APPENDIX E

WRITTEN AGENCY COMMENTS

TO: Antony J. Aloisio, Director of Planning and Environment
FROM: James J. Ahrens, P.E., Deputy Director of Engineering Services
DATE: September 11, 2019
RE: Review of APPENDIX H Geotechnical Engineering Reports – Indian Hills DEIS

**Comments on the
Draft Environmental Impact Statement
THE PRESERVE AT INDIAN HILLS
TOWN OF HUNTINGTON, SUFFOLK COUNTY, NEW YORK**

Map Amendment to NYS Regulated Freshwater Wetland N-8

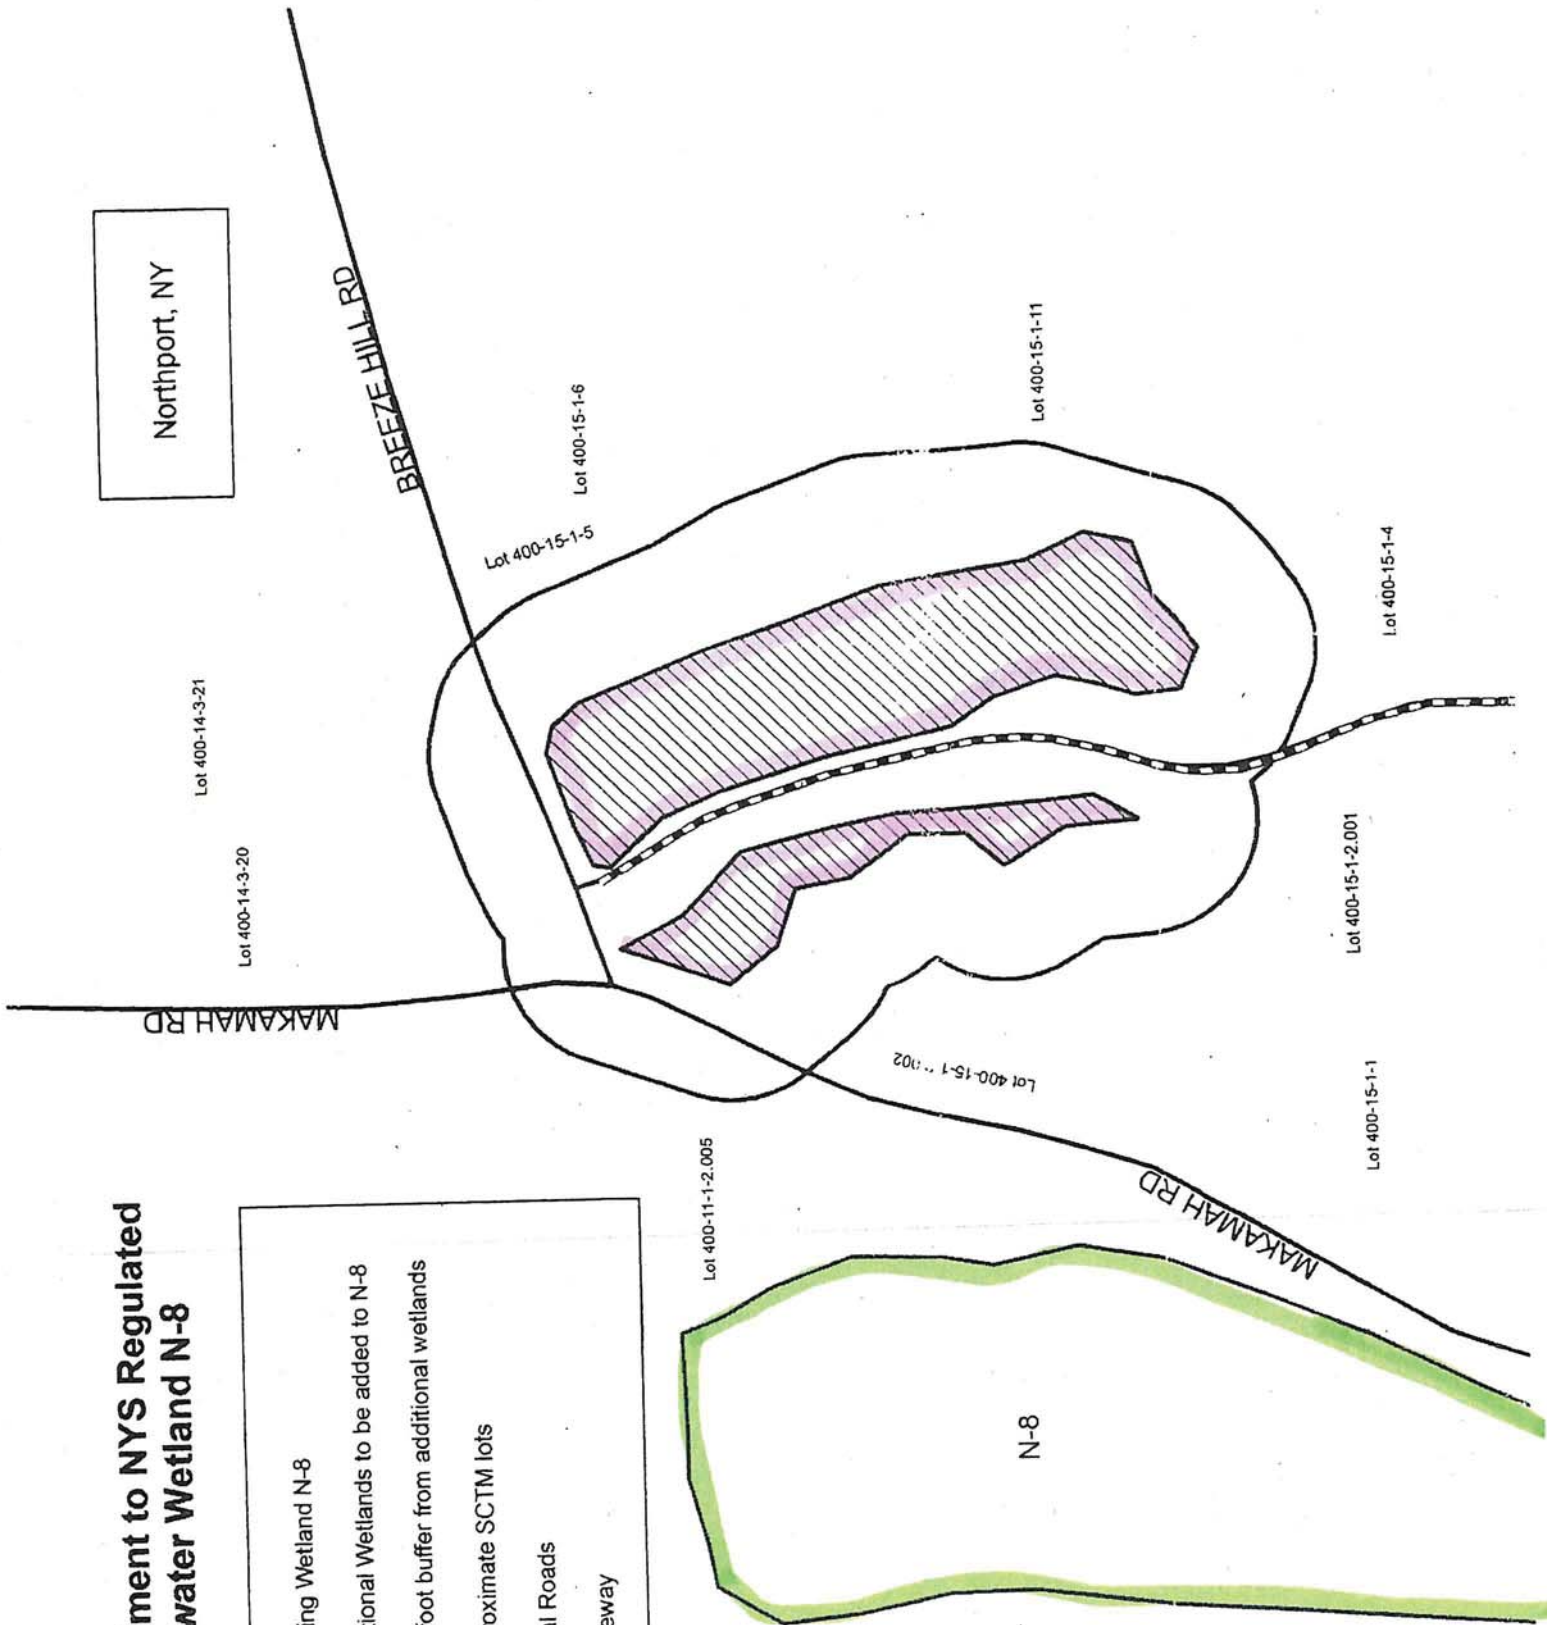
- Figure 2-4 NYSDEC Wetlands Map does not include the proposed map amendment as per the August 14, 2017 letter to the Town Supervisor (enclosed)
- Figure 2-8 Habitat Map does not include the parcel to the south west immediately adjacent to Makamah Road.

- Revise Figure 2-4 NYS DEC Wetlands Map in accordance with the NYSDEC letter, dated October 16, 2019, indicating the proposed map amendment of freshwater wetland N-8. E-238
